# Application for Dock Construction with Variances

BD-25-10-110

**Subject:** Patricia Doyle Monserez and Matthew Monserez Request for Variances for Dock Construction Permit BD-25-10-110

**MONSEREZ BOAT DOCK PLAN VIEW**  
**533 RIDGEWOOD DRIVE**  
**WINDERMERE, FL 34786**

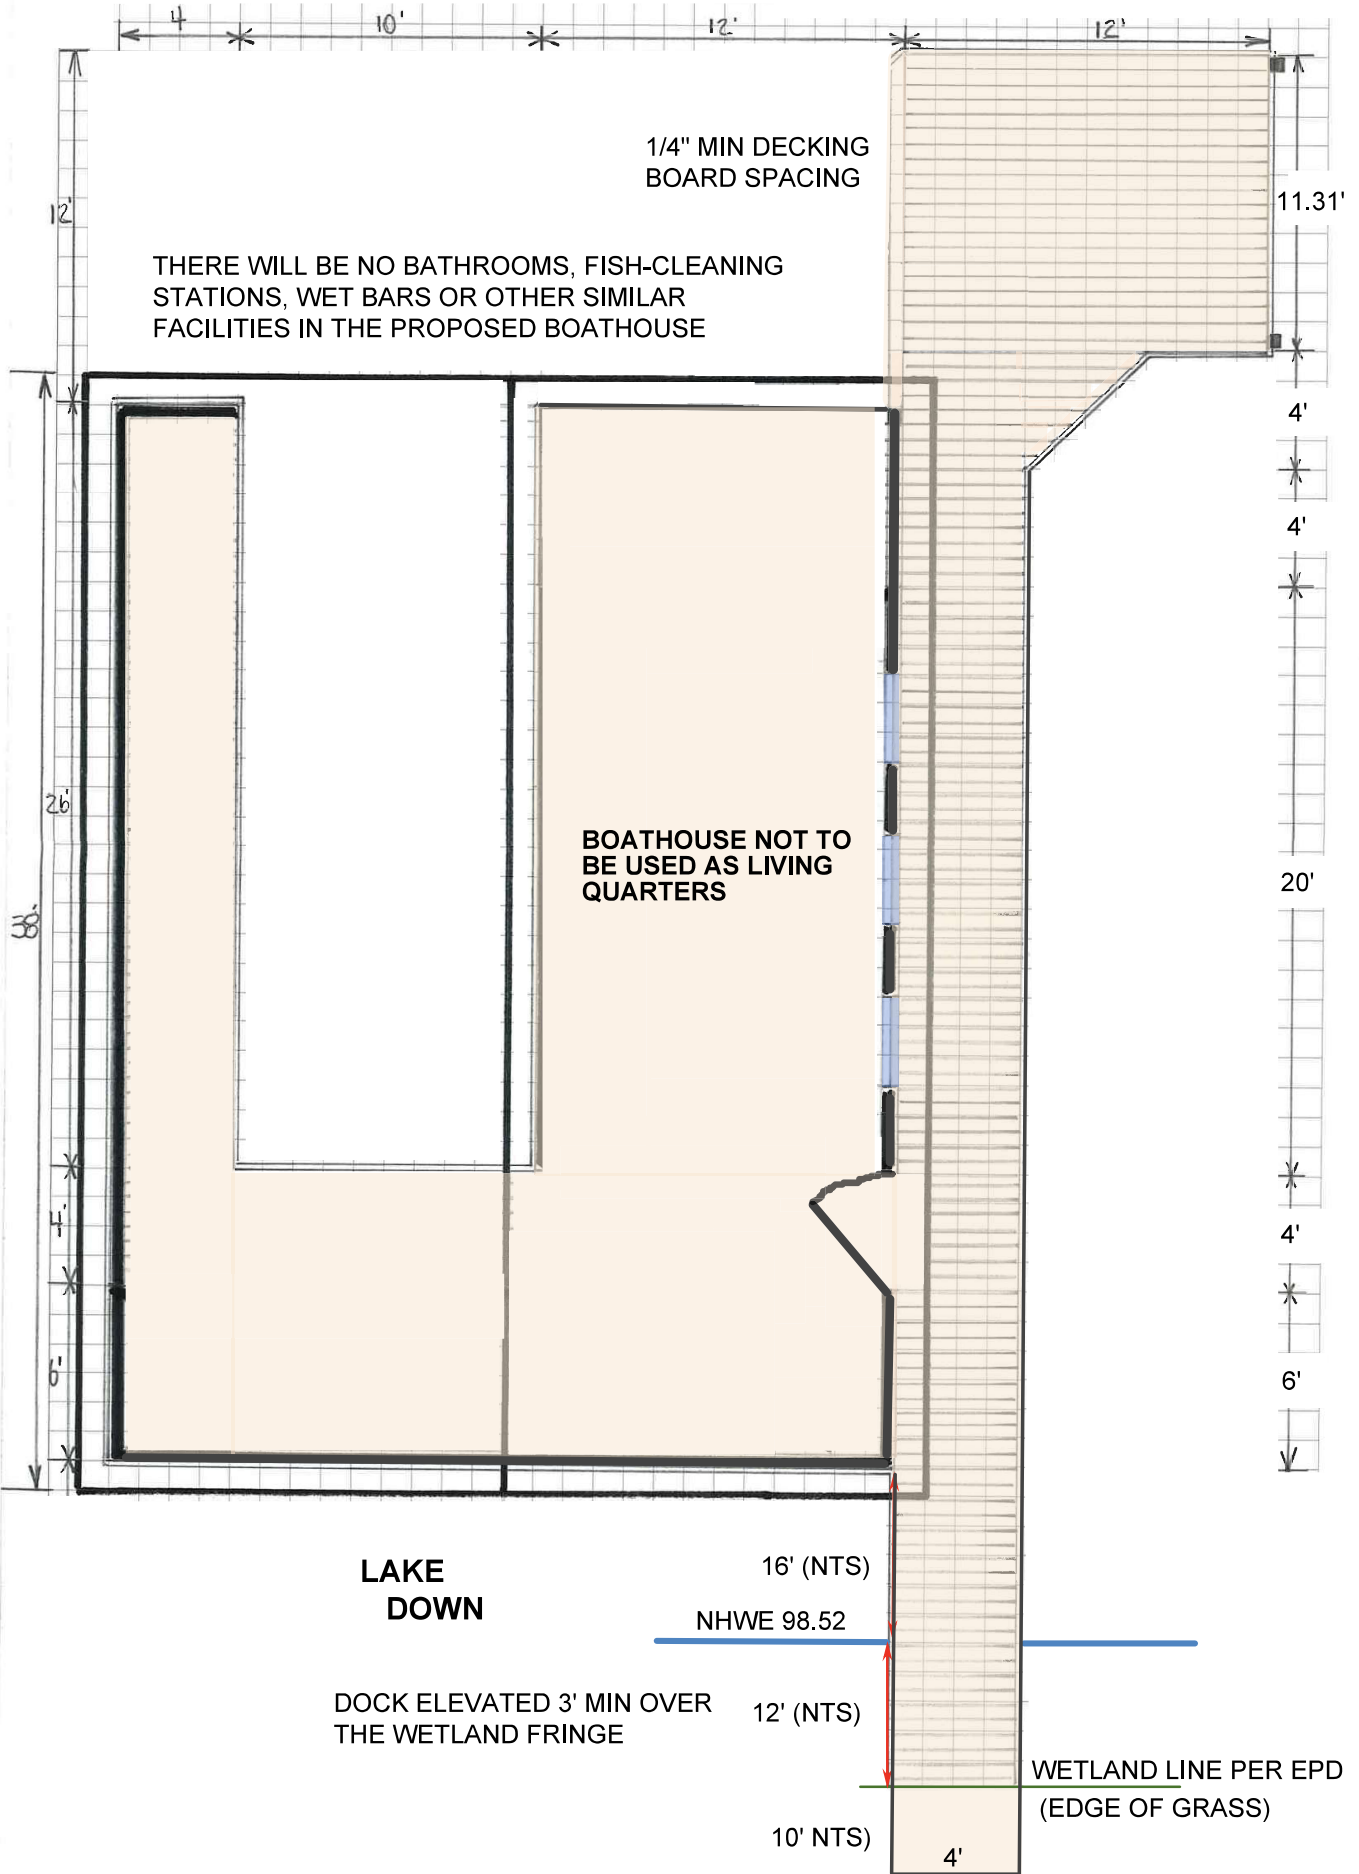
The proposed dock will have three solid, opaque walls on the boathouse that is located on the western portion of the terminal platform. The plans indicate that no bathrooms, fish-cleaning stations, wet bars, or other similar facilities will be constructed, pursuant to Section 15-342(a)(10).

The applicants have a shoreline that measures 100.2 linear feet at the Normal High Water Elevation (NHWE). The calculated allowable square footage for the dock terminal platform for the subject property is 1,000 square feet. The existing terminal platform is 1,232 square feet, based on the signed and sealed survey received by EPD on January 27, 2026. The applicants are requesting a variance to replace the existing terminal platform in the same footprint, with a terminal platform size of 1,232 square feet, which exceeds the allowable square footage by 232 square feet.

Variance #1 - MET: Staff has determined that there are negative impacts to surface waters associated with the requested variance, as the opaque walls will reduce sunlight reaching the lake bottom vegetation on the opposite side of the dock from the position of the sun. However, the proposed mitigation will fully offset the negative impact on the environment.

Variance #2 - MET: Staff has determined that there are negative impacts to surface waters associated with the requested variance, as the oversized terminal platform will increase shading of lake bottom vegetation. However, the proposed mitigation will fully offset the negative impact on the environment.

Variance #1 - NOT MET: The applicants have not demonstrated that impacts to the natural resource have been minimized pursuant to Section 15-322(d), as a dock without opaque walls that does not reduce sunlight reaching lake bottom vegetation to the same extent could be constructed.

Variance #2 - NOT MET: The applicants have not demonstrated that impacts to the natural resources have been minimized pursuant to Section 15-322(d), as a smaller dock that does not reduce sunlight reaching lake bottom vegetation to the same extent could be constructed. Further, the proposed request pre-empts other members of the public from using the 232 square feet above the allowable terminal platform size.

The recommendation of the EPO is to deny the request for variances to Section 15-342(a)(1) (enclosed dock), and Section 15-342(a)(5) (terminal platform size) based on staff's findings that the applicants have failed to satisfy the variance approval criteria in Section 15-350(c)(2) through (5), as a functional dock that meets the requirements of the Code could be constructed on the subject property.
